## High Oil Consumption – 3.0 Litre EFI V6

MERCURY/MARINER  
1995 thru 1998, 3.0 Litre EFI V6  
S/N 0G129222 thru S/N 0G760300

#### Standard Setting

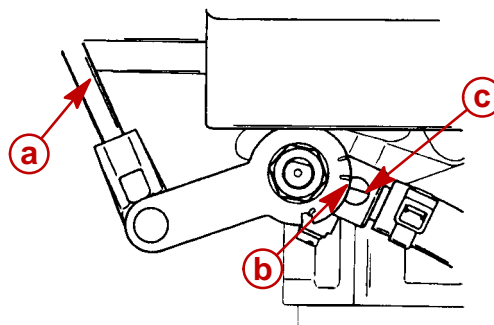
There have been reports of high oil consumption and excessive smoking at lower speeds on 3.0 Litre EFI Models. Incorrect oil link rod geometry between 1200 to 3200 RPM could cause an incorrect oil to fuel ratio.

When an engine comes in for service, or before being sold inspect the engine for standard oil link rod adjustment as outlined in section 2C of service manual (P/N 90-822900R3). Removing the port lower cowl and shift anchor assembly will be necessary to check for proper oil pump cam location. Once the standard setting has been made, lengthen the oil link rod 3 full turns. This new setting will correct the oil link rod geometry, and should improve the oil consumption.

#### New Setting
